**Epic Mining Pty Limited
Luddenham Clay/Shale Quarry
Modification 4 of Development Consent DA315-7-2003
Response to Submissions – January 2017**

This Response to Submissions Report (RTS) has been prepared by National Integrated Creative Solutions on behalf of Epic Mining Pty Limited (the applicant).

B1 Revised Schematic Flowchart of Water Management System – 21 December 2016

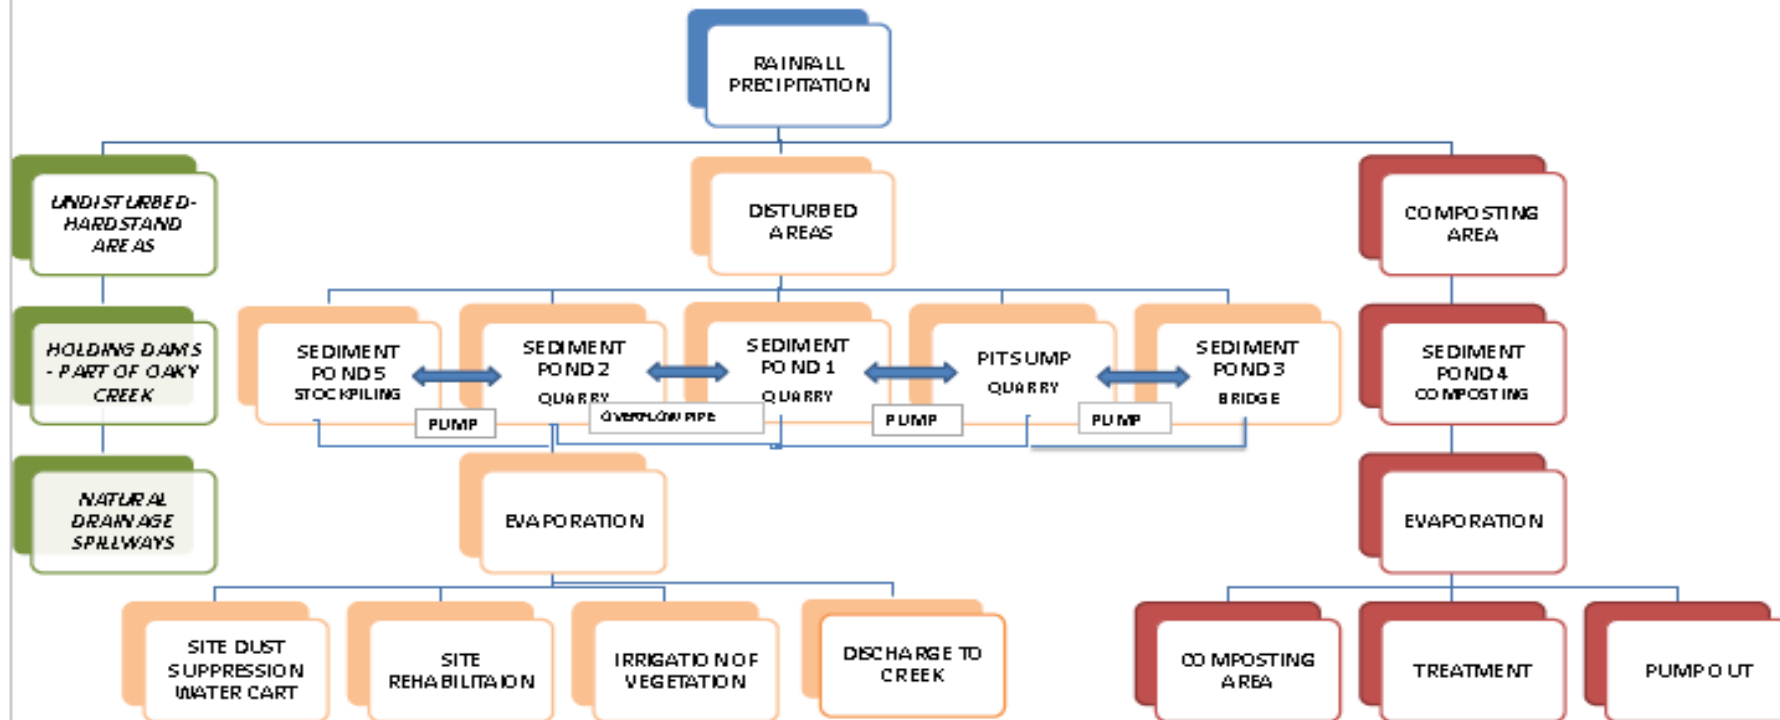
- b. With regards to the proposed surface water management system, please provide:*
 - a revised schematic flowchart (Figure 6-4) to reflect the potential water discharges into Oaky Creek and provide a revised map (Figure 6-6) showing the licensed discharge point;*

- additional information regarding the "pump out" of surface water from the composting area (as shown in Figure 6-4); and*
 - additional information on the proposed management of clean vs non-clean surface water on site.*

Refer to **Attachment B** of this document for new figures, maps, plans, etc.... as requested above.

D1 Noise Calculation Scenarios

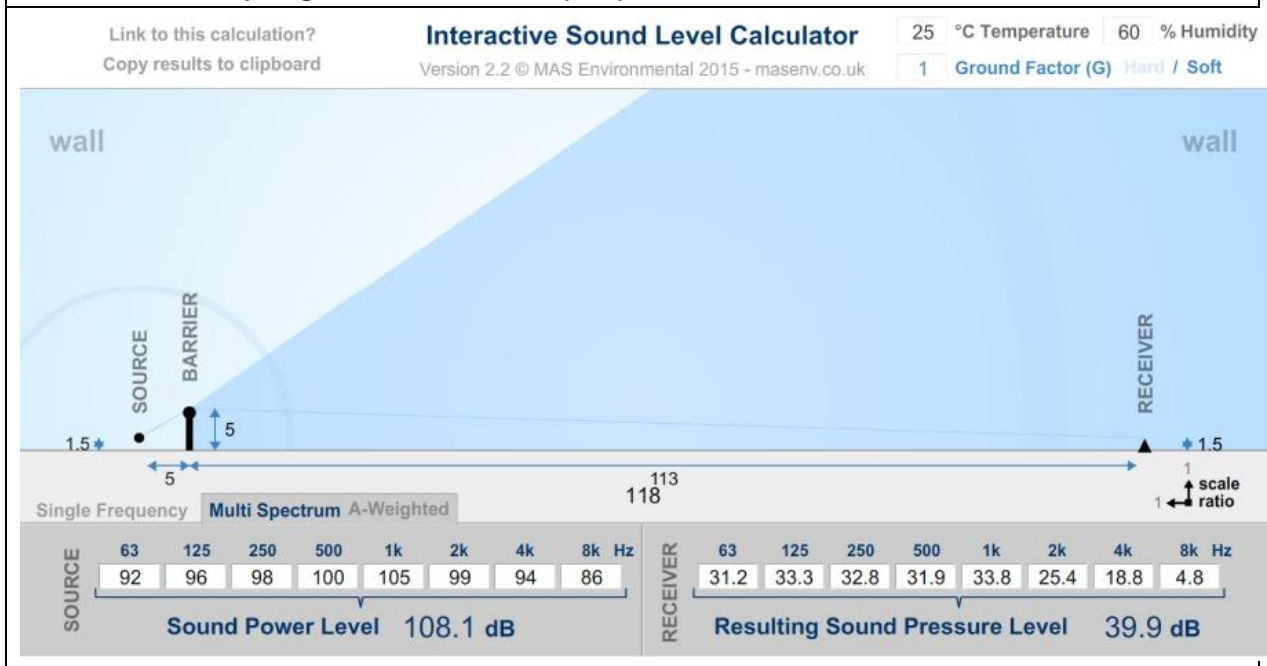
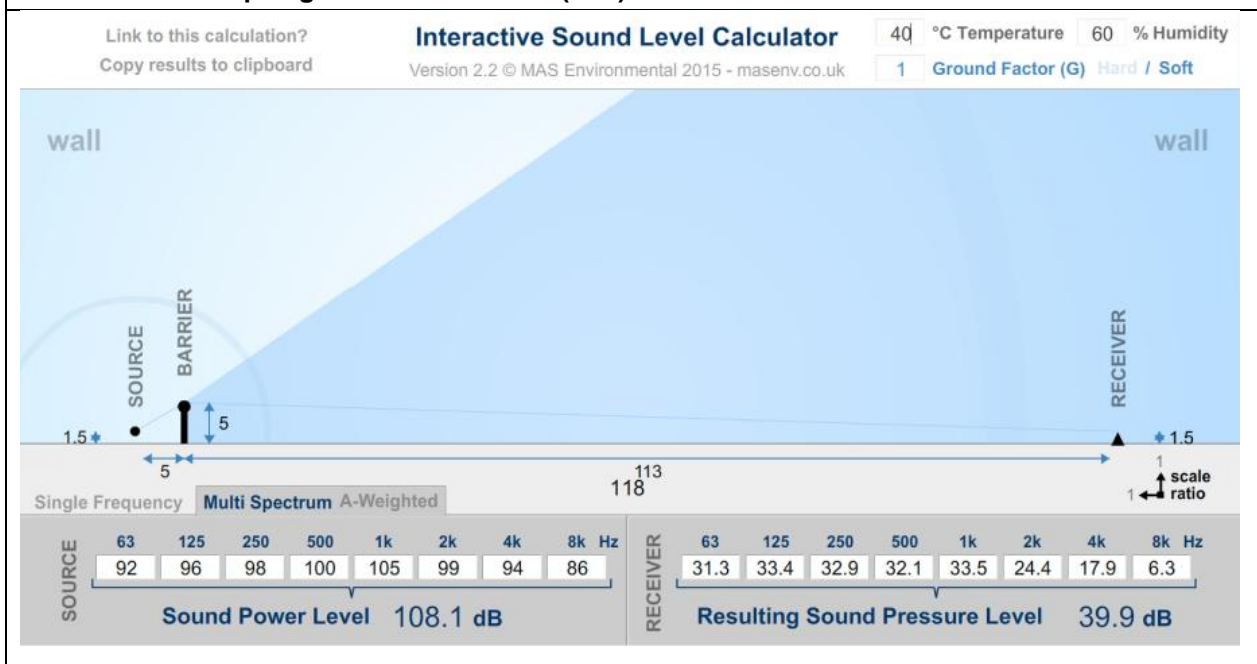
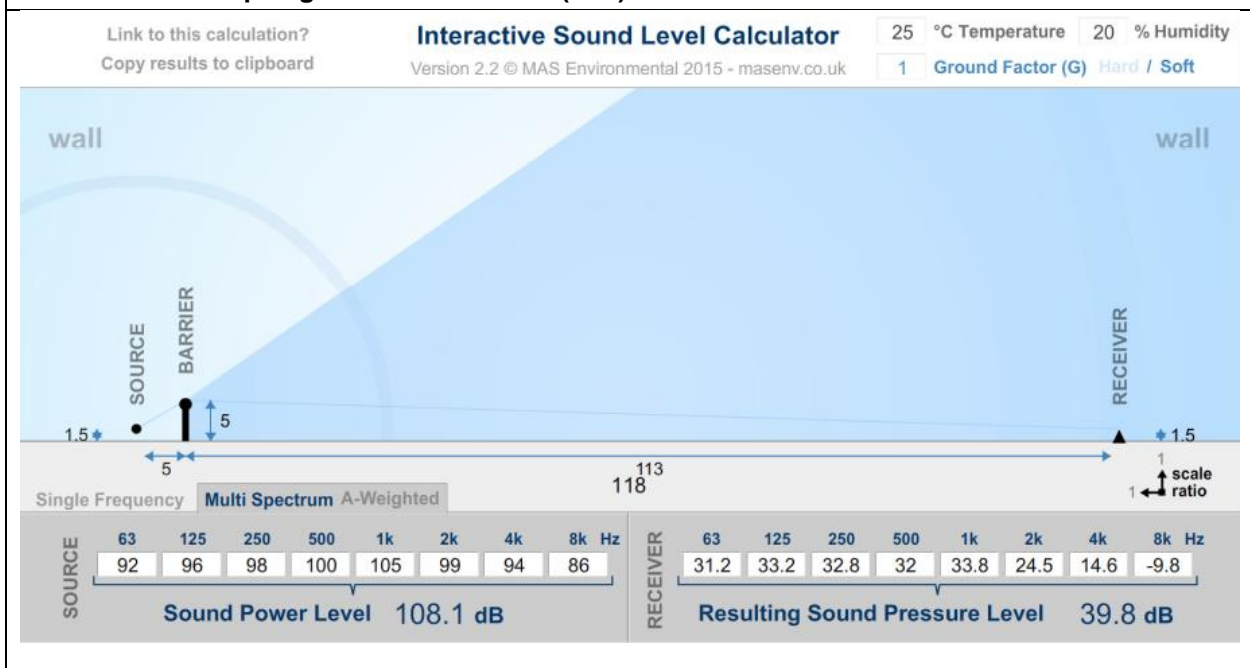
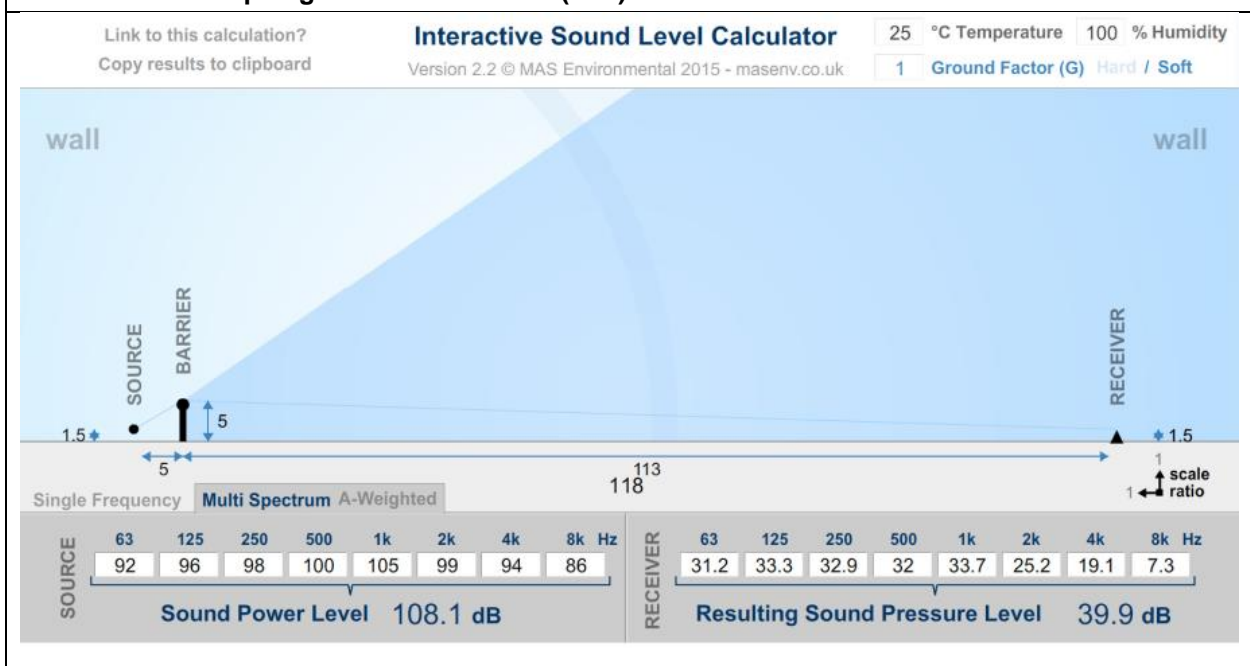
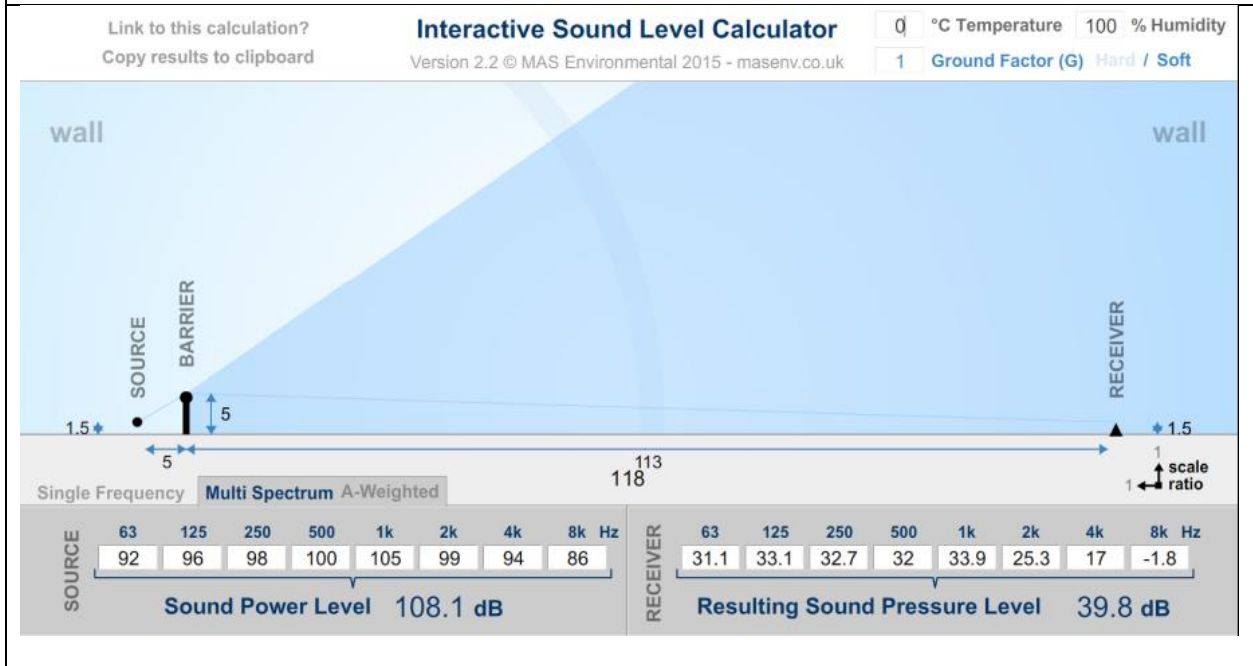
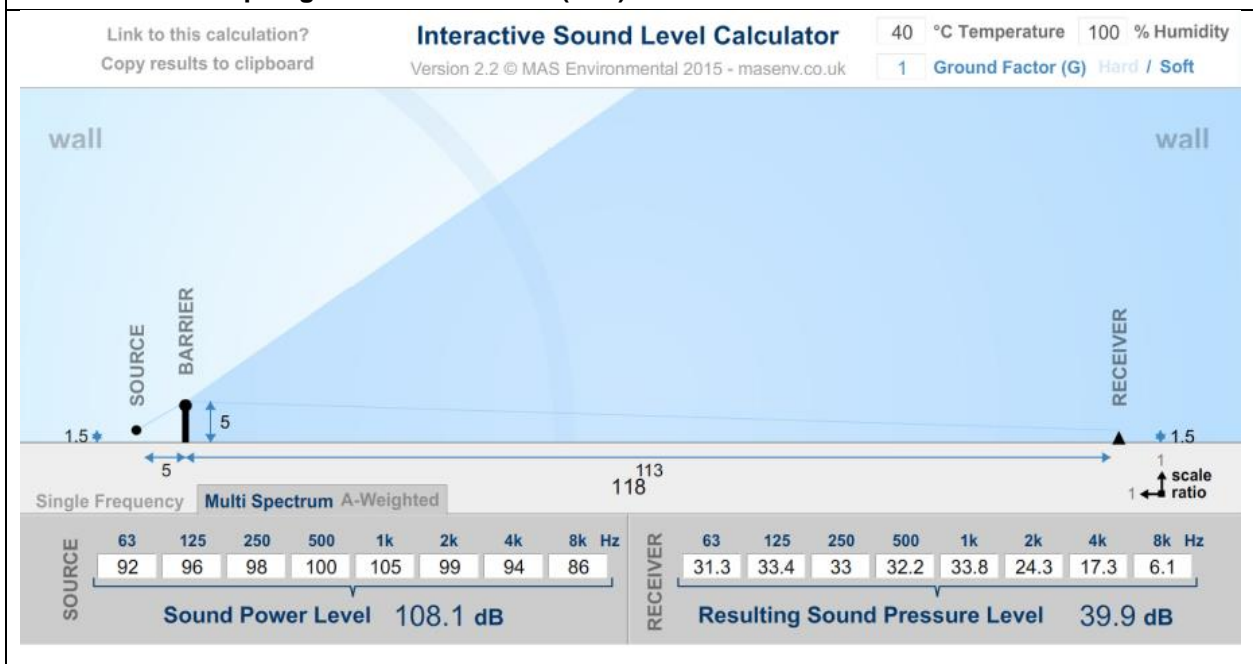
The Department appreciates that background noise levels may have increased, however it is not in a position to consider the proposed project specific noise levels (PSNLs) in Table H2 of Appendix H of the EA unless the levels are supported by adequate noise modelling. Please provide additional information to support the proposed noise criteria.

Following the review of all presented scenarios, it is clearly evident that by changing the temperature between 0-40 °C and the relative humidity between 20-100%, the highest change in calculated noise levels is a reduction of 0.6 dB(A) which is considered to be positive rather than negative change.

By changing the ground from hard (factor of 0) to soft (factor of 1), the change in calculated noise levels is a reduction of only 0.7 dB(A) which is considered to be positive rather than negative change since most of the areas between the noise source and receivers are soft rather than hard except the roadway.
